# Public Meeting Summary

Oklahoma Department of Transportation

SH-20 Claremore

From Franklin Road (NS-411) to SH-66  
Rogers County, JP 26242(04)(07)

**Figure 3: Proposed Alignment Shift at Rose Glen**

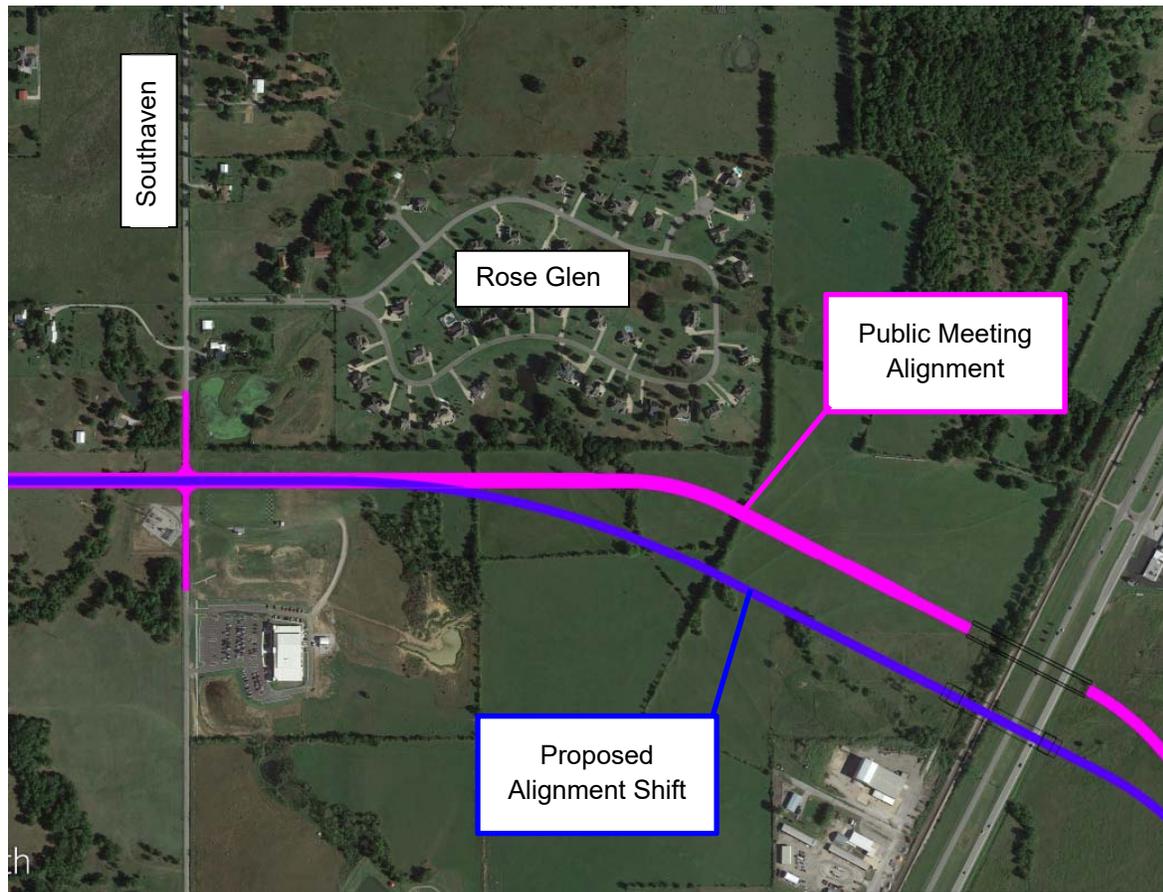
| Proposed SH-20 should be moved farther south at Rose Glen. .  | 25        |

ODOT has investigated alignment options to the south of the Destiny Life Church and these options would introduce less desirable geometry (i.e. more curves), impact additional floodplain area, and add more cost to the project. In response to concerns regarding noise at the Rose Glen neighborhood, ODOT will consider an alignment that begins to transition south at a point further west than the alignment presented at the public meeting (see Figure 3). This additional modification will shift traffic away from Rose Glen.

Modifications were made to the original approved preferred alignment in 2017 in an effort to account for the changes in land use and development that have occurred in the project area since the alignment was approved. Some comments expressed a preference for the original, 2000 alignment. While some properties may be affected more by the modified alignment, these proposed modifications to the original alignment were made to reduce the overall number of potential impacts in the corridor.
